Altec Industries, Inc. has issued a **customer satisfaction campaign** as described in the included Service Information Letter (SIL). According to our records, you own one or more units this applies to.

## LR8 Lanyard Detection System Calibration

**Units Affected:** Certain LR8 aerial devices built from January 2021 to October 2024. Verify your unit is affected by reviewing the attached list or accessing Altec Connect.

**Figure 1 — Lanyard Detection System Fiber Optic Transmitter**

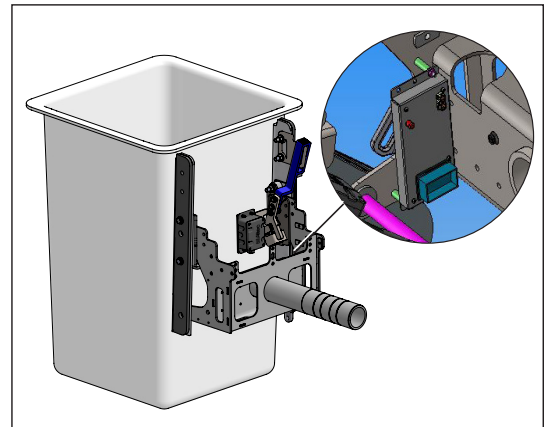
4. Locate the fiber optic transmitter for the lanyard detection system mounted near the upper control valve (refer to Figure 1). Inspect the electrical harness connection points for any signs of corrosion.

- a. If no corrosion is present, proceed to step 5.
  - b. If corrosion is present, attempt to clean the transmitter connector pins and/or the electrical harness connector pins.

- c. If cleaning is unsuccessful or components are damaged, order replacements for the affected component(s). Record findings in Figure 3.
    - Fiber optic transmitter: part number 990409144.

- Electrical (battery) harness: part number 990532616.
5. Locate the lanyard flag. Pull the lanyard flag toward the platform and release it to confirm that it springs back smoothly to its original position.

**Figure 2 — Switch Engagement Mechanism**

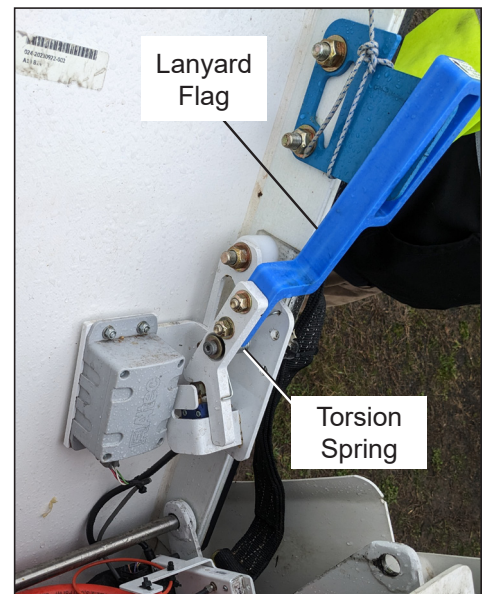
- a. If the lanyard flag does not spring back smoothly, it may be required to replace the torsion spring. Record findings in Figure 3.
    - For front mounted LR units this is part 991063815.

- For rear mounted LR units this part is 991063814.
  - b. Proceed to step 6.

**Figura 1 — Sistema de detección de cordón con transmisor de fibra óptica**

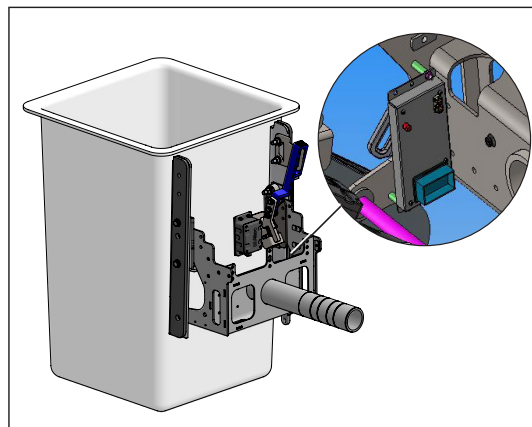
4. Ubique el transmisor de fibra óptica del sistema de detección del cordón de seguridad, montado cerca de la válvula de control superior (consulte la Figura 1). Inspeccione los puntos de conexión del arnés eléctrico en busca de signos de corrosión.

- a. Si no hay corrosión, proceda al paso 5.
- b. Si hay corrosión, intente limpiar los pasadores del conector del transmisor o los pasadores del conector del arnés eléctrico.
- c. Si la limpieza no es exitosa o los componentes están dañados, ordene reemplazos para los componentes afectados. Registre los hallazgos en la Figura 3.
  - Transmisor de fibra óptica: número de parte 990409144.
  - Arnés eléctrico (de batería): número de parte 990532616.
